**ADDENDUM NO. 1
TENDER NO. 99-20
BYNG ROAD REHABILITATION**

July 3, 2020

TYPICAL SUPPORT CROSS SECTION

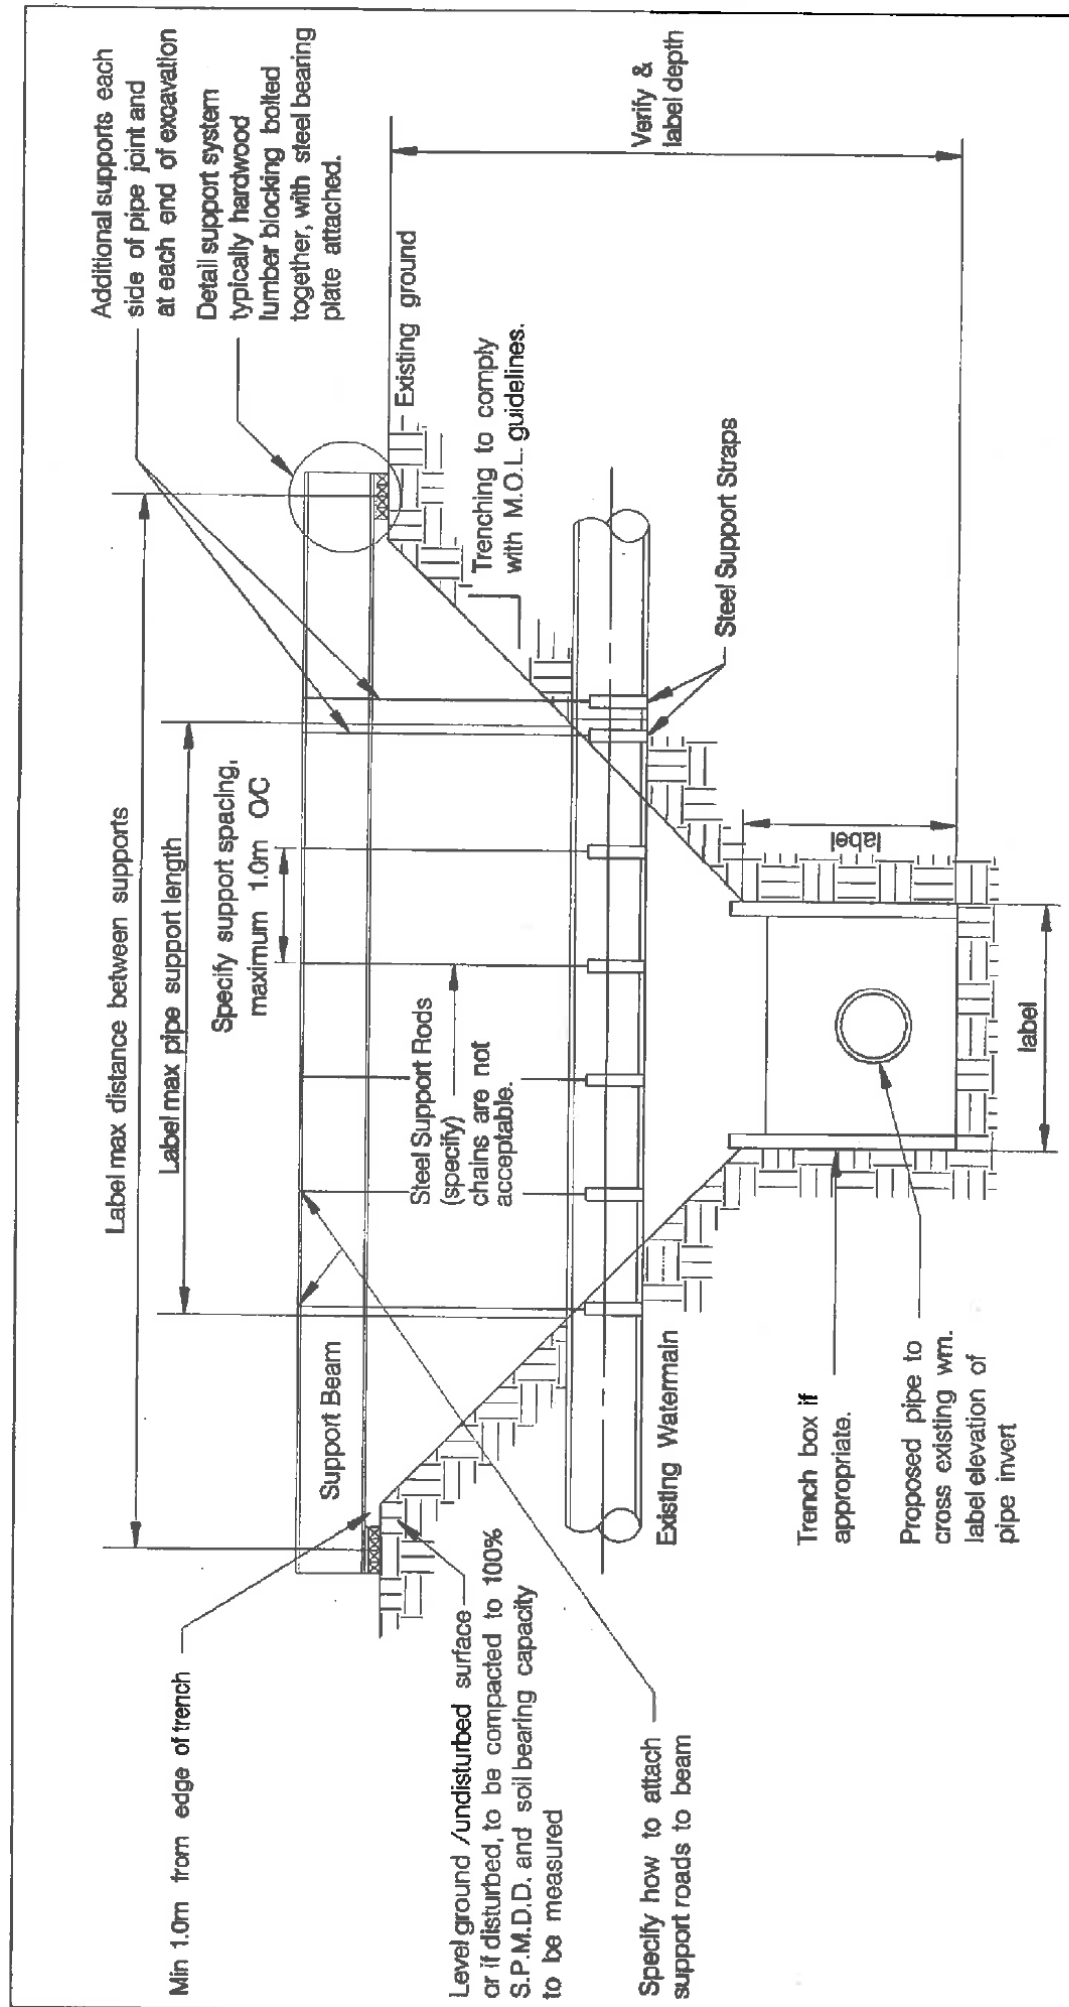
The feedermain will need to be supported and an appropriate support must be designed by a Professional Engineer and approved by Enwin as follows:

- provide plan layout (structures to scale) showing extent of excavation crossing feedermain including manholes, trench widths and trench boxes, etc.
- submit for review and approval the following prior to the proposed work taking place. No work may proceed until received and approved:

- Support Detail Requirements:
 - A Utility support system drawing stamped by a professional Engineer, including the following: (see typical drawing attached pg 1)

- Complete plan and cross-section drawings indicating support system including all appropriate dimensions and details.
 - Provide all structural calculations for support systems including load and deflection information for proposed beam. Provide details to confirm adequacy of support mechanism proposed to transfer loading of supported utility to support beam.

- Provide calculations for loading transferred to the end support of the beam structure and confirm adequate soil bearing capacity for the system designed for beam supports.

- Identify procedure for transferring load of structure to be supported to support beam.
 - Bedding / Reinstatement Detail Requirements.
 - The drawings shall include the following: (See typical drawing attached pg 2)

- Cross-section drawing(s) including all appropriate dimensions and details
 - To prevent settlement of watermain, install 0.7MPa unshrinkable fill with bond breaker (ie 6mil poly or blueskin) from centreline of utility up to the centreline of watermain.
